# Turnpike Design Website

## Change/Update Request

The attached drawing provides information to designers for the treatment of guardrail post installed in areas with soils that exceed the standard AASHTO soil requirements for guardrail post. The application in Florida is specific to limestone in South Florida. This information is based on FHWA Memorandum dated March 10, 2004. Roadway Design request this drawing be added to the Turnpike Design web site under Guide Drawings for use by Consultants doing business with Florida's Turnpike Enterprise.

Subject: INFORMATION: W-Beam Guardrail Installations in Rock and in Mowing Strips Date: March 10, 2004

Attachments

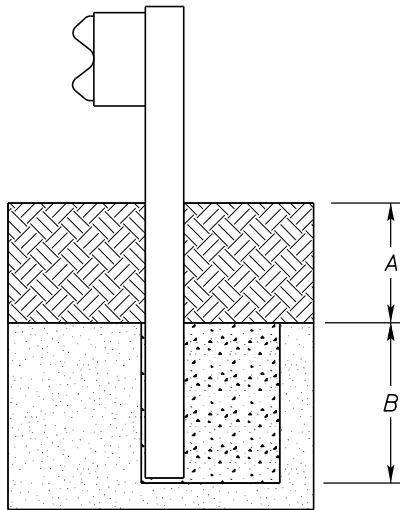
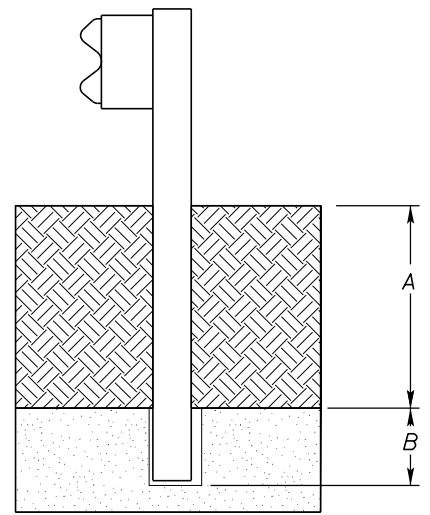
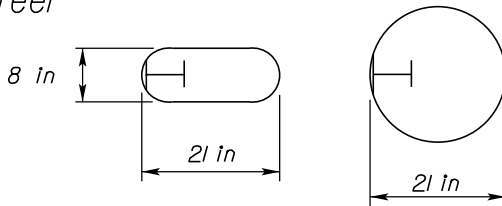
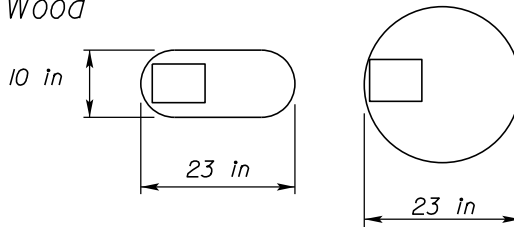
The first of these was the MwRSF report entitled "Development of Guidelines for Placement of Guardrail Posts in Rock" by Rohde and Herr. The authors' final recommendations for guardrail placement in rock are summarized in Enclosure 1. Simply stated, posts in solid rock should be set near the roadside edge of 530-mm to 580-mm diameter shafts drilled 610-mm (24-inches) deep, and backfilled with a compressible material (ASTM C33 coarse aggregate, size no. 57) so the post can rotate back approximately 380 mm (15 inches) at the ground line upon impact. For locations where the solid rock is below the surface, the size and depth of the drilled shaft will vary as noted as the enclosure, depending on the depth of soil above the solid rock.

For overlying soil depths (A) ranging from 0 to 18 in, the depth of required drilling (B) is equal to 24 in.

For overlying soil depths (A) ranging from 18 in to the embedment depth of the post, depth of required drilling (B) is equal to either 12 in or the desired embedment depth minus the depth of soil which ever is less.
